SB-GA8-2020-201
Issue 1

Service Bulletin

Pressure Sensors Hub Installation

Figure 2: View looking at the three AN832-4D/J fittings on the forward face of the firewall.

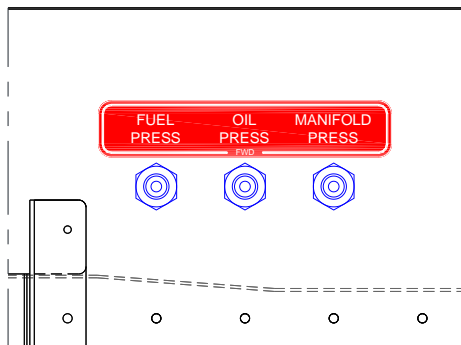
3. Disconnect the flexible fluid lines, for the Fuel Pressure, Oil Pressure and Manifold Pressure gauges, from the three respective fittings on the forward face of the firewall identified in Figure 2. Cap the lines to prevent contamination and stow the lines in a safe location.

Figure 3: View looking aft at the forward face of the firewall.

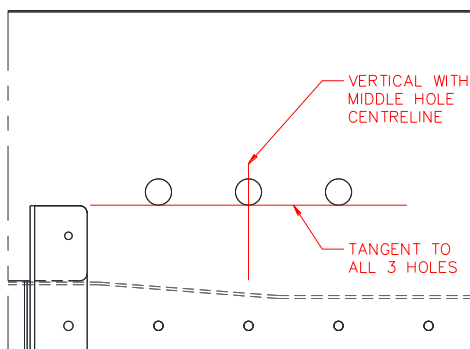
4. Where fitted, disconnect and remove the Fuel Pressure, Oil Pressure and Manifold Pressure hose assemblies from the three fittings on the aft face of the firewall and the back of each corresponding gauge installed within the instrument panel. Cap the now exposed port of each gauge to prevent contamination.
5. Remove the three AN832-4D/J fittings from the firewall. Note that all three fittings are secured in place with an AN924-4D/J nut and an AN960-716 washer on the aft face of the firewall. Use a scraper or similar to clean off residual firewall sealant.
6. Where fitted, remove the Fuel / Oil / Manifold Pressure placards from both the forward and aft face of the firewall. Discard both placards.
7. Using a non-destructive method, mark two lines on the firewall, as per Figure 3, using the three existing 7/16" (0.4375") diameter holes as a reference.

Figure 4: View looking aft at the forward face of the firewall. All dimensions are in inches.

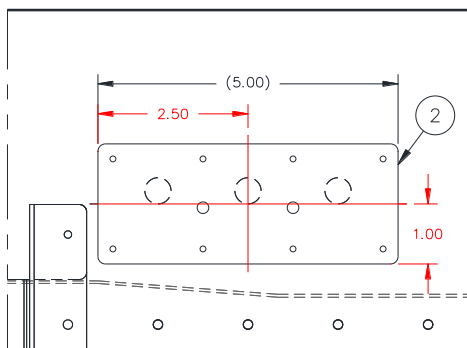
8. Position Item 2, as per Figure 4, using the lines marked in Step 7 as a reference. On the firewall, mark the eight 0.098" diameter holes and two 0.193" diameter holes that exist in Item 2.

9. Drill the two larger holes, marked in Step 8, to between 0.190" and 0.193" in diameter. Recommended drill sizes: #11 (0.191") or 4.9mm (0.193").
10. Drill the eight smaller holes, marked in Step 8, to between 0.125" and 0.135" in diameter (3.2mm to 3.4mm). Recommended drill sizes: #30 (0.128") or 3.2mm (0.126").

Figure 5: View looking aft at the forward face of the firewall.

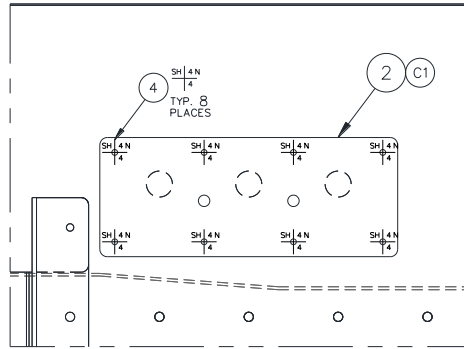
- As per Figure 5, wet assemble Item 2 with Item C1 (or Item C2 if C1 is unavailable) using eight of Item 4. Ideally, Item 4 is to be installed with the head of the rivet on the forward face of the Firewall, however, if access is not possible, the rivet may be installed in reverse.

Figure 6: Main view looking aft at the forward face of the firewall. Item 1 assembly fittings have been omitted from the exploded view for clarity.

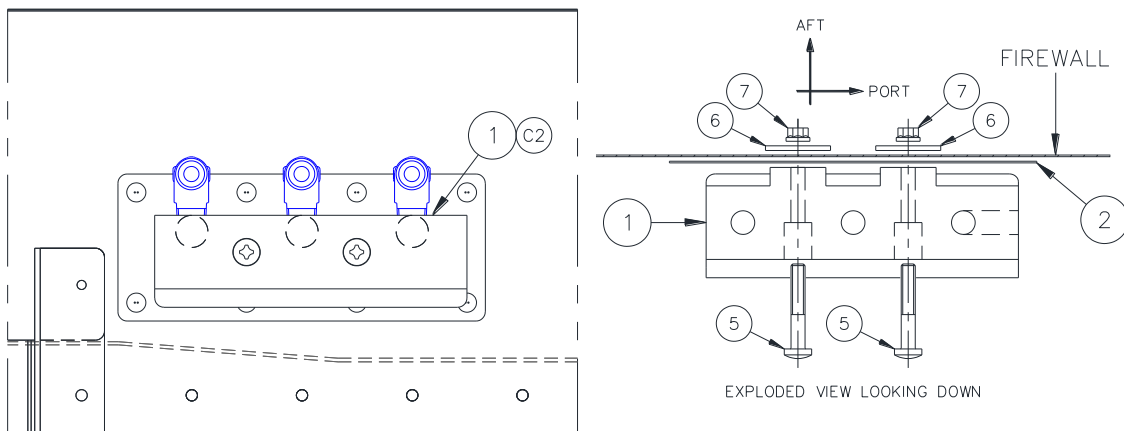
- Apply a sufficient amount of Item C2 to the faying surfaces of Item 1 and install to the forward face of Item 2 using two each of Item 5, 6 and 7, as per Figure 6.

Figure 7: View looking aft at the forward face of the firewall. Dimension is in inches.

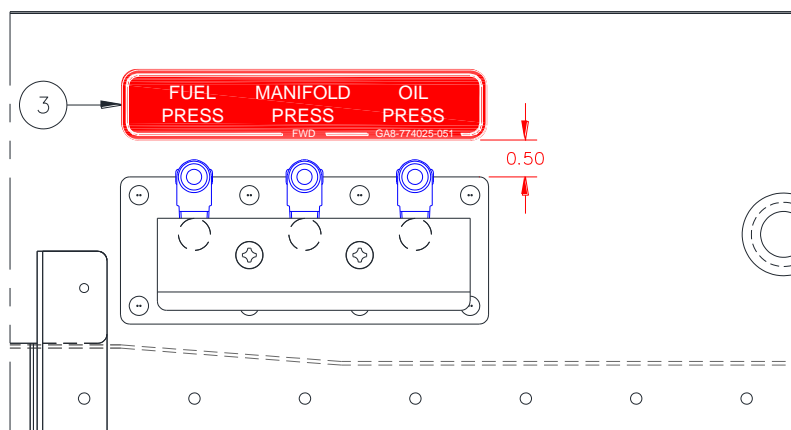
- Cap each of the three AN822-4D fittings, existing in Item 1, to prevent contamination.
- Affix Item 3 to the forward face of the firewall as per Figure 7. Note that a similar placard is no longer required on the aft face of the firewall.

Figure 8: Installation of pressure sensors detailed in Table 5.

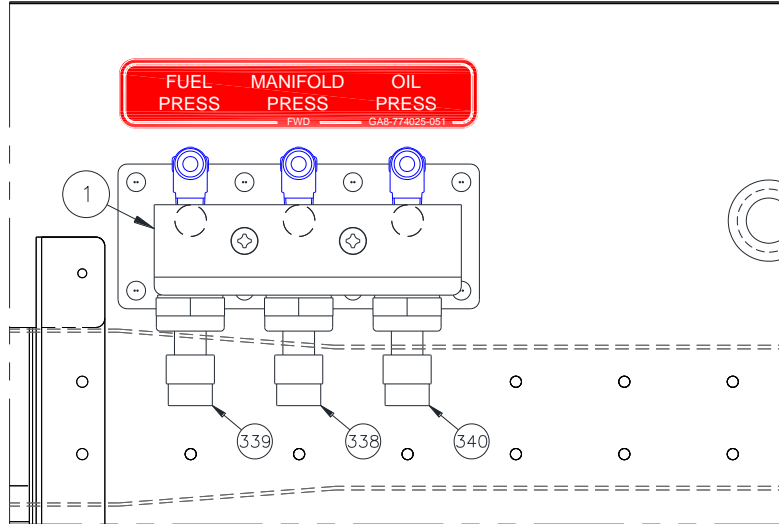
16. Apply Item C3 sparingly to the threads of the pressure sensors detailed in Table 5, omitting the first 2 threads, and install each pressure sensor to Item 1, as per Figure 8. Ensure that each pressure sensor is installed into the correct 1/8"-27 NPT tapped hole and that no leaks can occur.

Figure 9: Installation of the pressure switch detailed in Table 6.

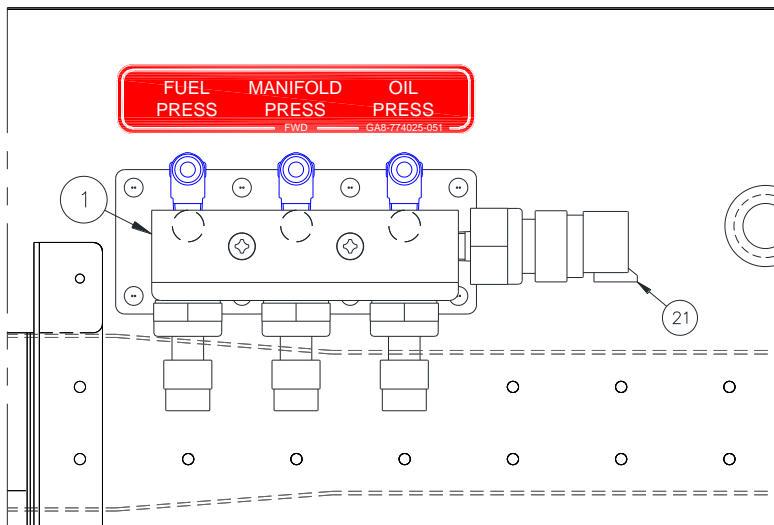
18. Apply Item C3 sparingly to the threads of the pressure switch detailed in Table 6, omitting the first 2 threads, and install the pressure switch into the 1/8"-27 NPT tapped hole in Item 1, as per Figure 9. Ensure that no leaks can occur.
